RHODE ISLAND DEPARTMENT OF TRANSPORTATION

Rt 5 - Lambert Lind Hwy C-1 (Mayfield Ave - I-95)

NOTICE TO PROSPECTIVE BIDDERS

ADDENDUM NO. 1 Prospective bidders and all concerned are hereby notified of the following changes in the Plans, Specifications, Proposal and Distribution of Quantities for this contract. These changes shall be incorporated in the Plans, Specifications, Proposal and Distribution of Quantities, and shall become an integral part of the Contract Documents.

TYPICAL BRIDGE SECTIONS

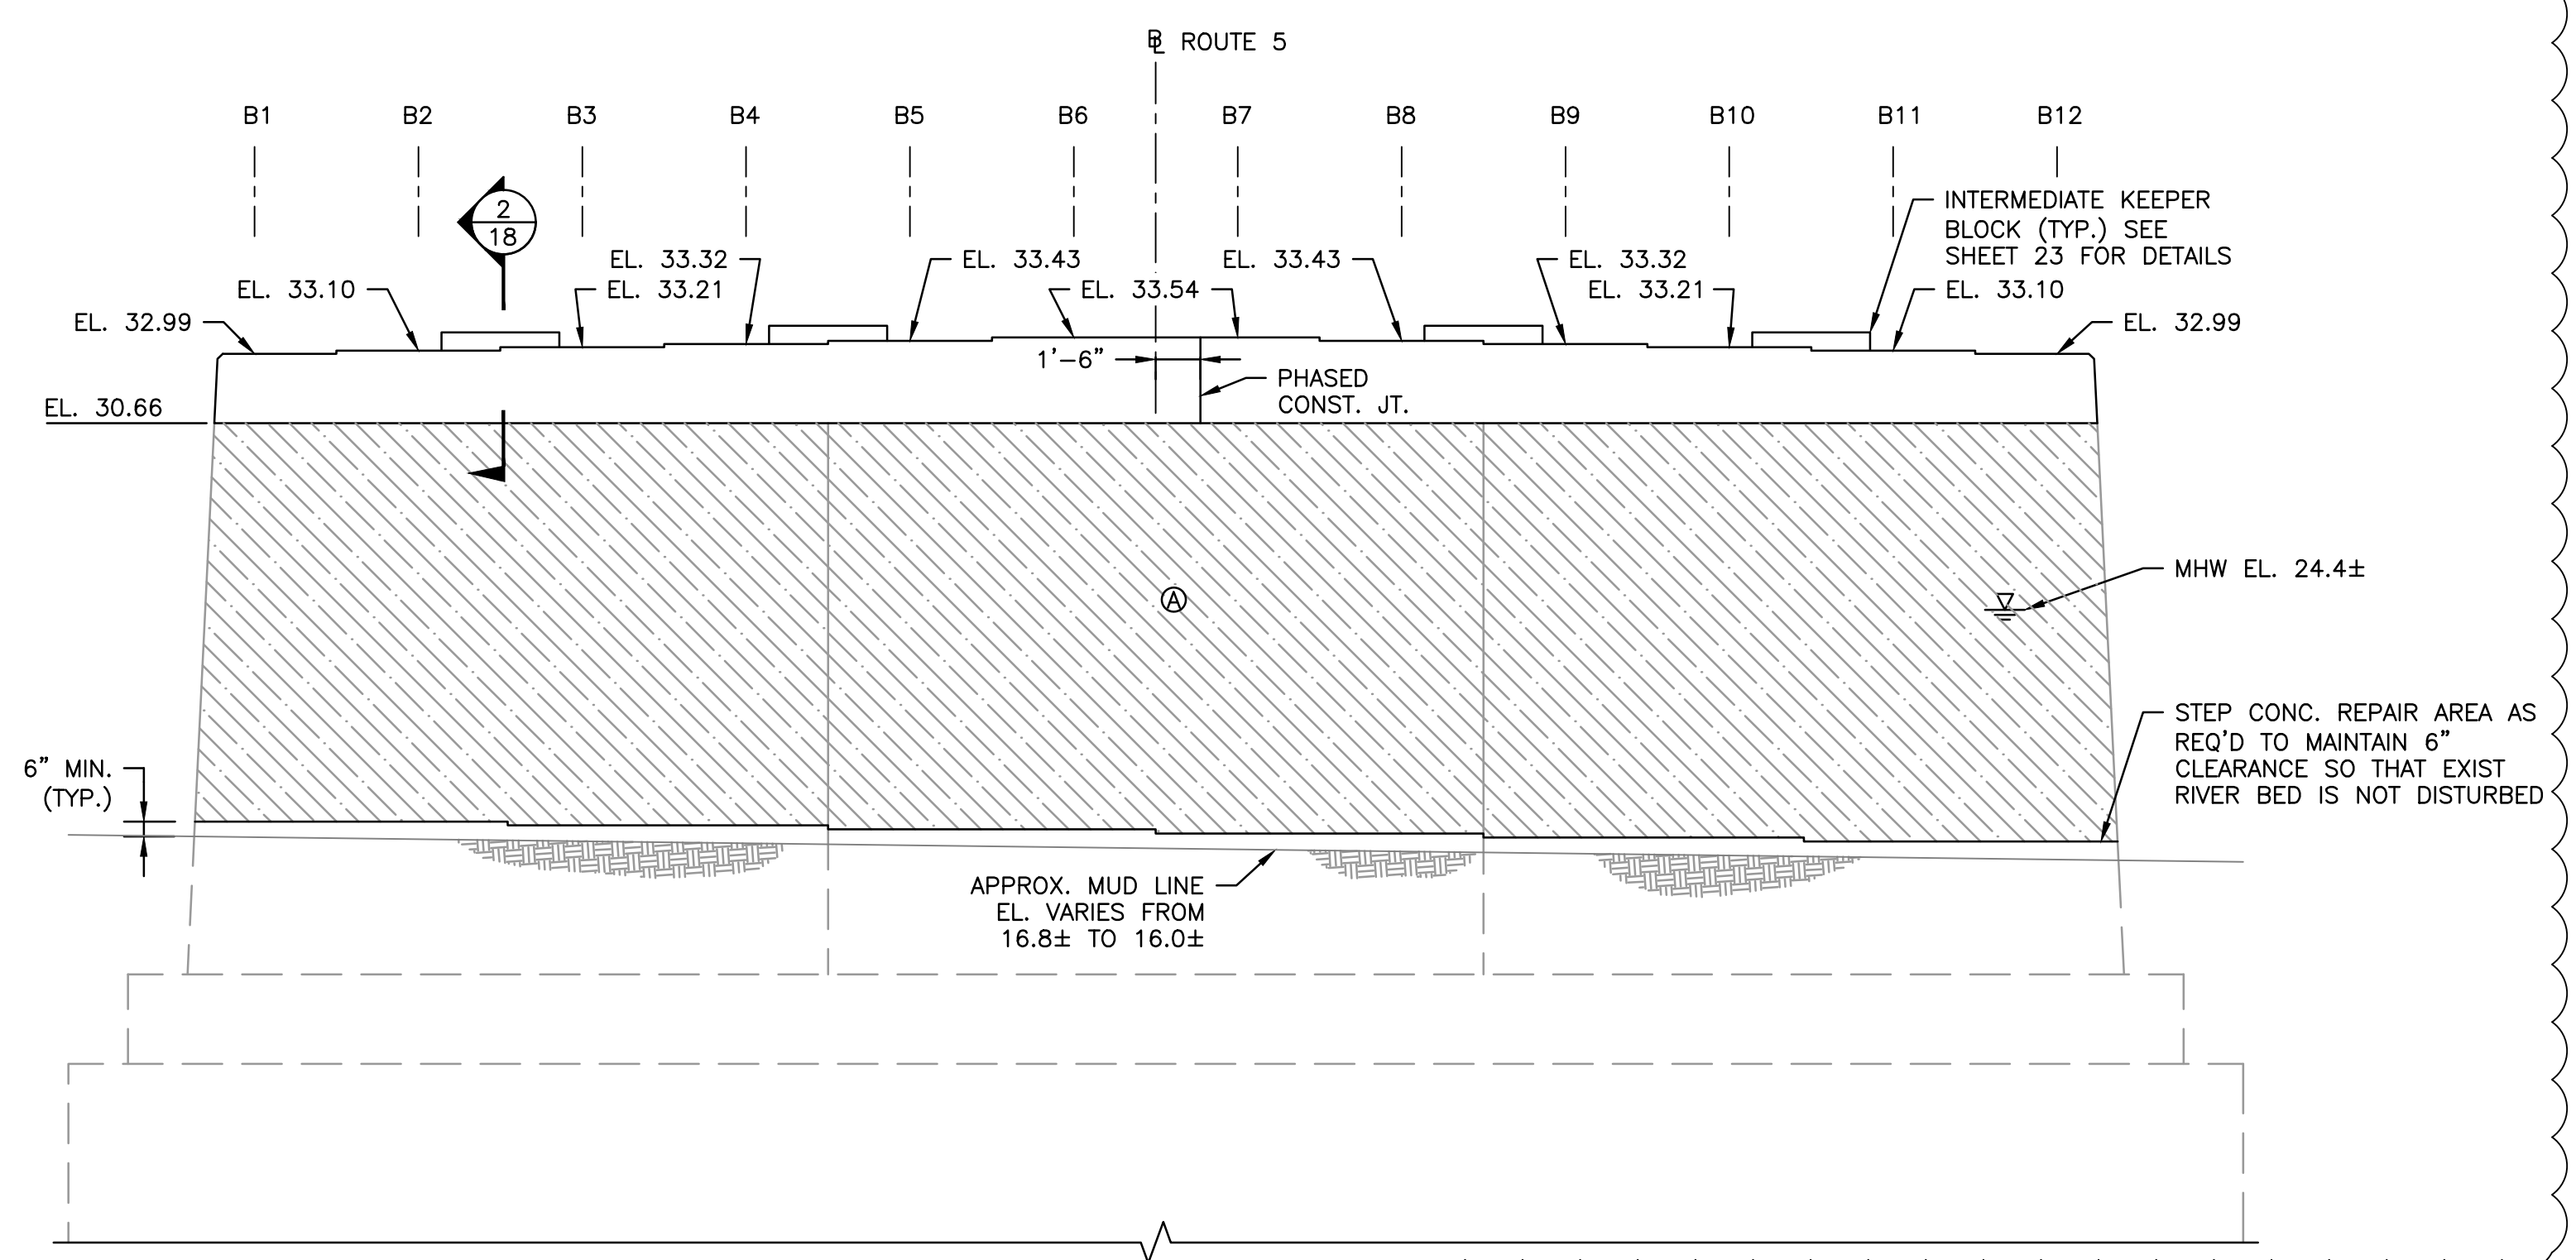
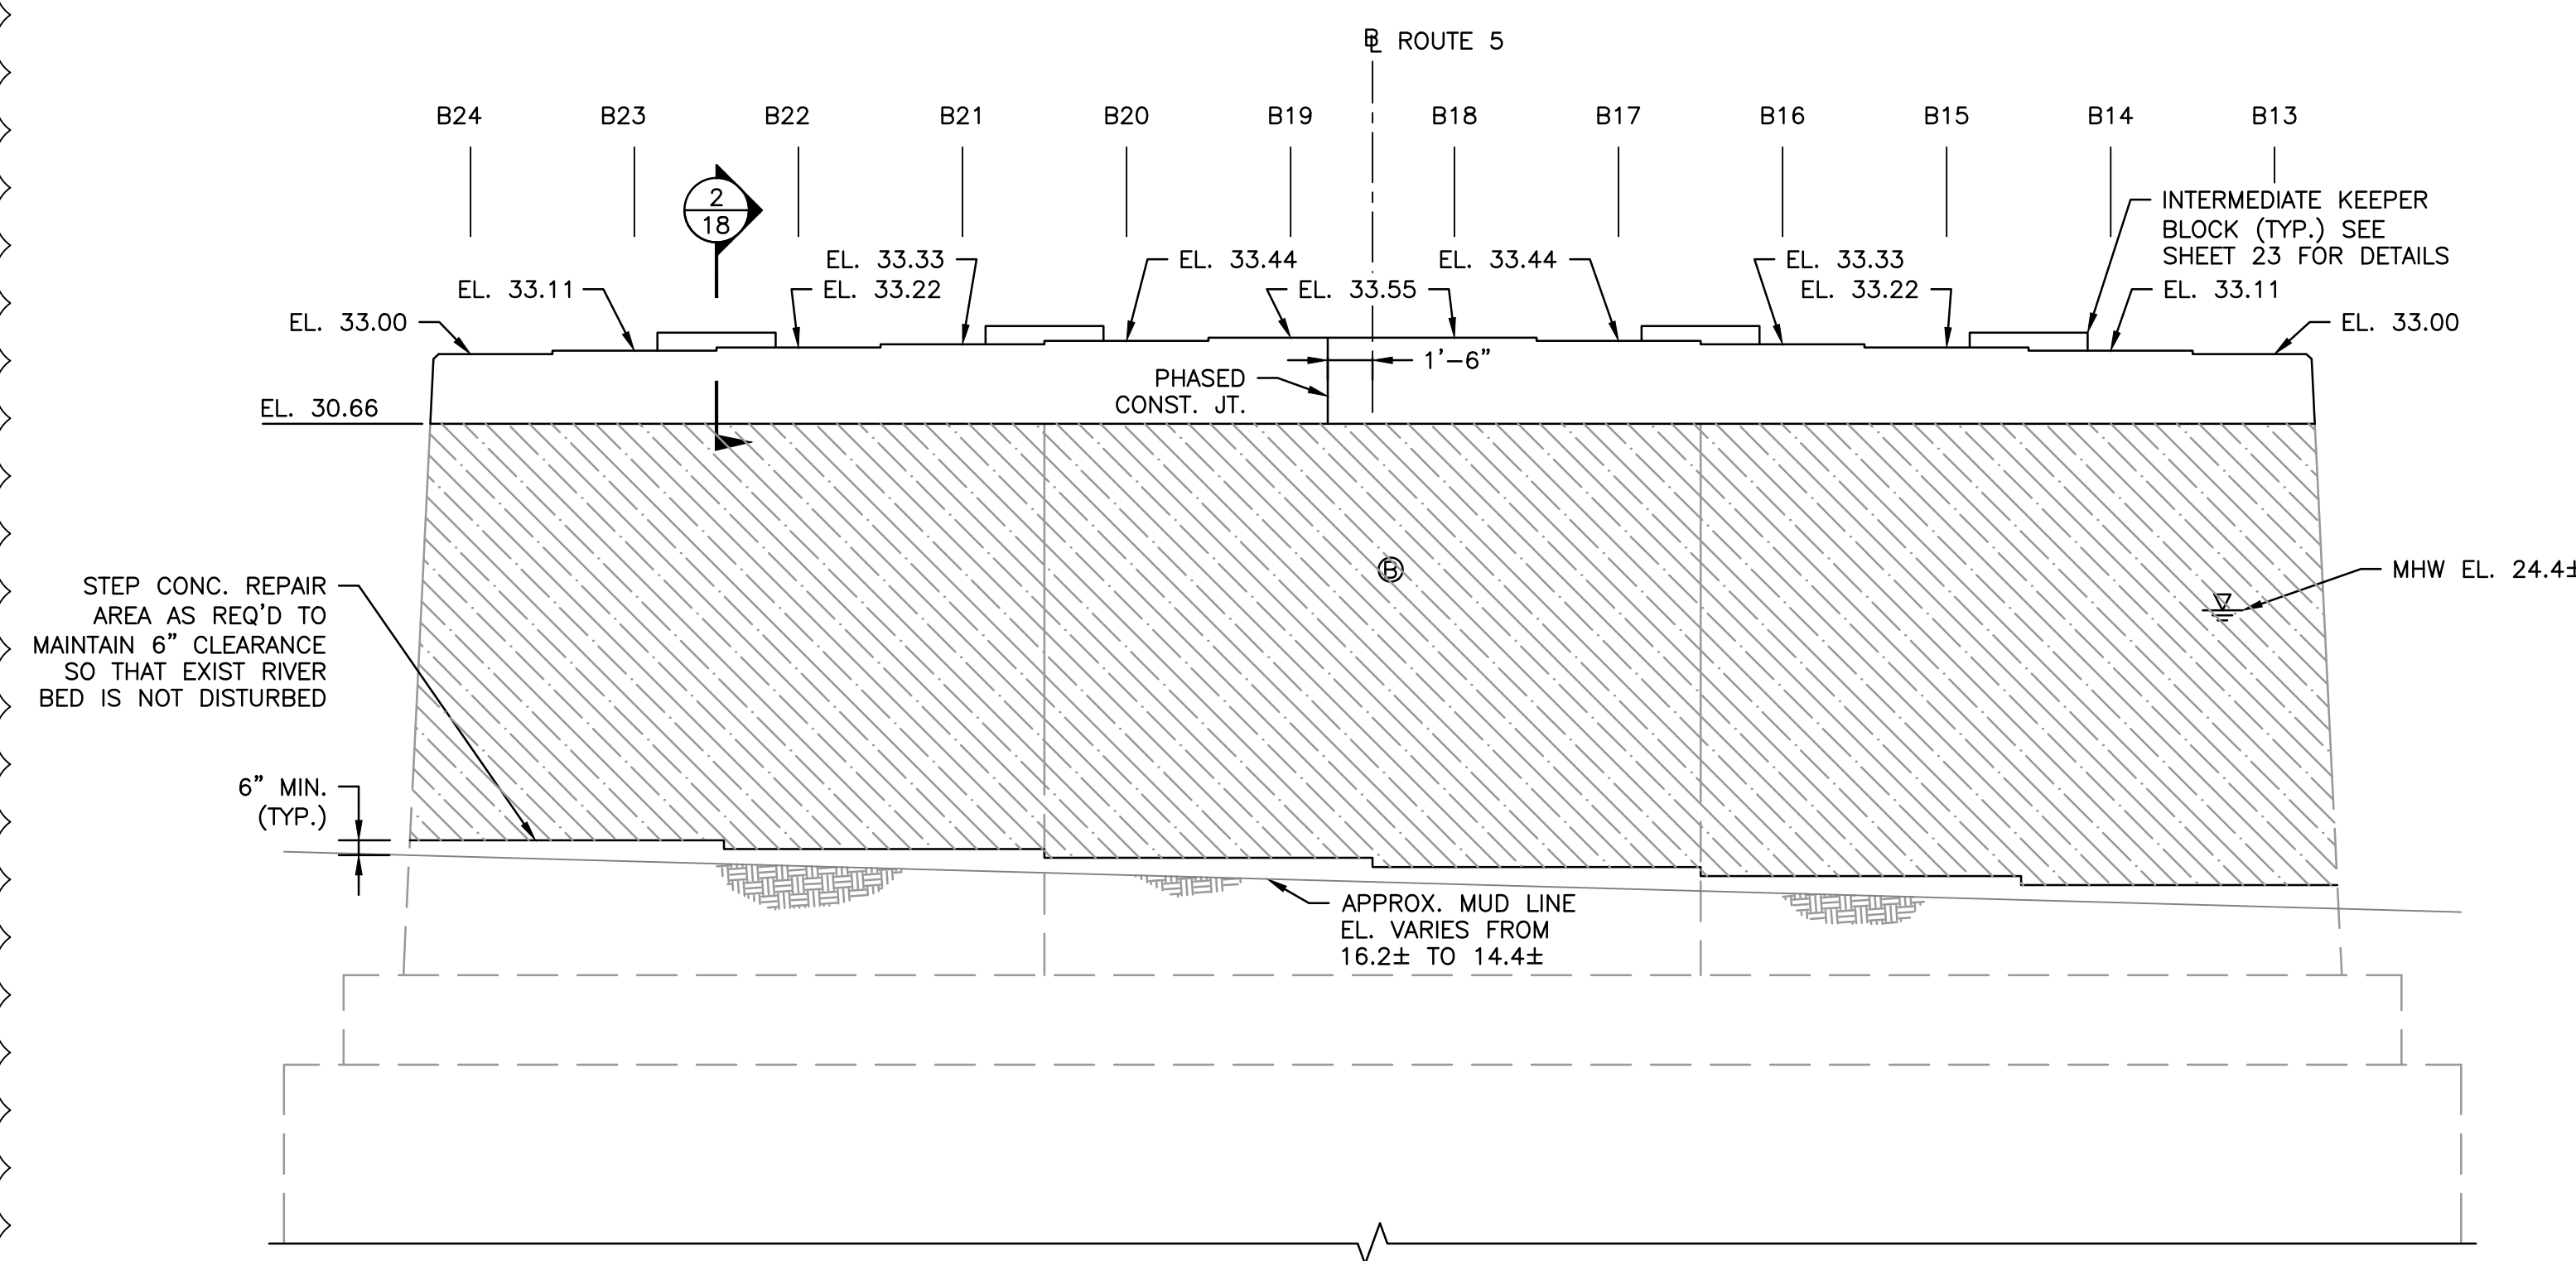
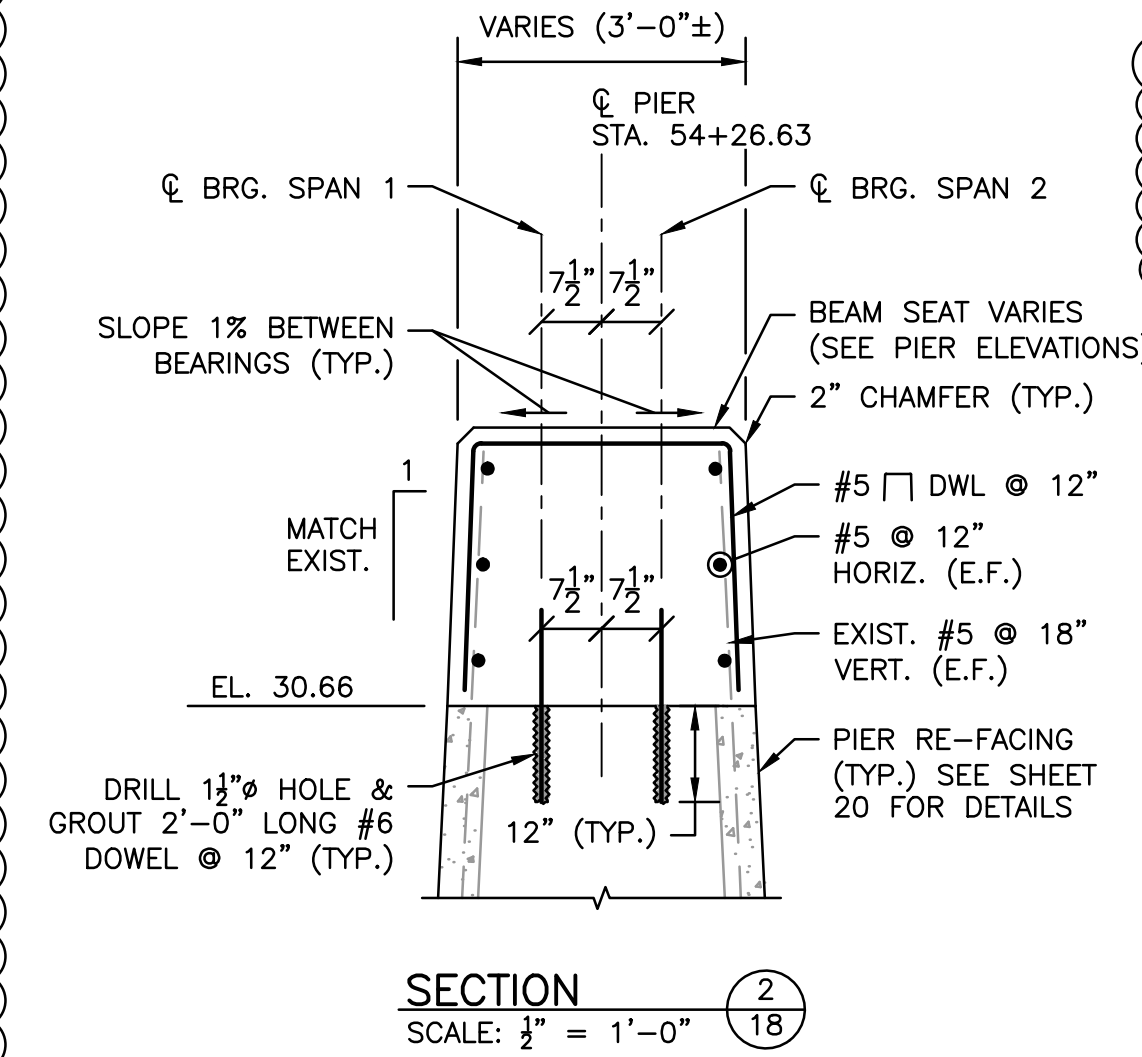
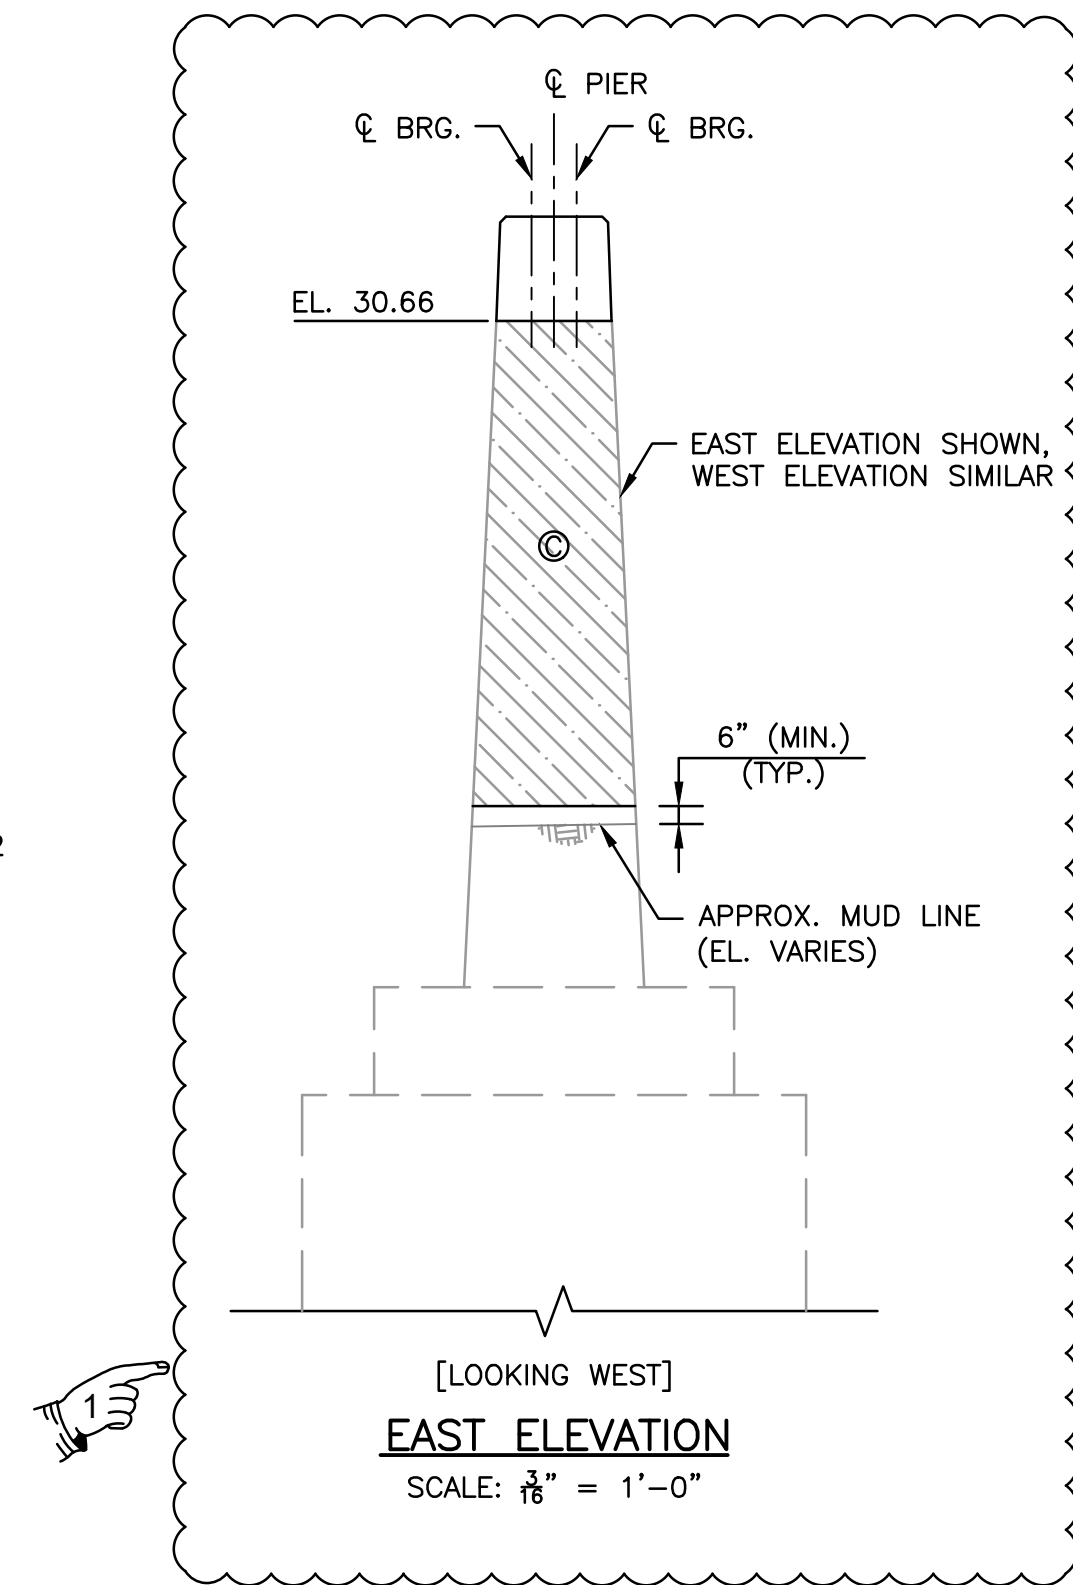
In Volume 2, the 'Mud Line' elevations shown on Sheet 10 of 36 appear very different from the elevations noted on Sheet 17 of 36. Please clarify which bottom elevation represents the actual field conditions.

In Volume 2, the 'Mud Line' elevations shown on Sheet 10 of 36 appear very different from the elevations noted on Sheet 18 of 36. Please clarify which bottom elevation represents the actual field conditions.

Approximate mud line elevations on Sheet 10 and 18 have been edited per the 2017 RIDOT Underwater Inspection Report and will be included as part of Addendum 1.

Approximate mud line elevations on Sheet 10 have been edited to match Sheet 17. Sheet 10 Rev1 will be included in Addendum 1.
